Access Compliance Report Public Rights-of-Way (RR Crossings)

Intersection ID: 14235	Main Street: CAMDEN_RD	Location: N/A
ADA ID: 057FC2649C4D	Overall Compliance: No	Severity Score: 0.0
Codes/Mitigation Info/Possible Solution		Field Measurements/Component Compliance

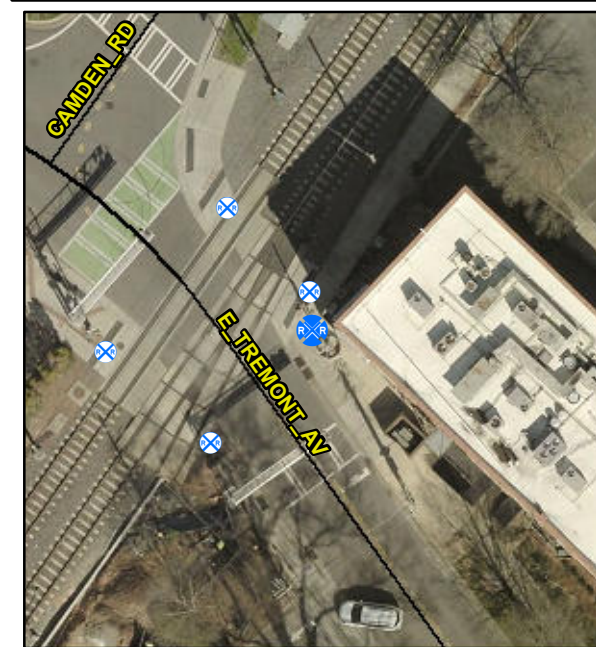
Remove & Replace Detectable Warning System. Provide Pedestrian Gate. Remove & Replace Walking Surface Adjacent to Rail.

Compliance	Description	Data
Yes	DWS Provided?	Yes
Yes	DWS Contrast?	Yes
Yes	DWS Width (in)	Yes
Yes	DWS Length (in)	24.0
No	DWS Offset (in)	40.0
No	Pedestrian Gate?	No
N/A	DWS Outside Gate?	No
N/A	Rail Type?	LightRail
No	Flangeway Gap (in)	3.0
Yes	Sidewalk Width (in)	93.0
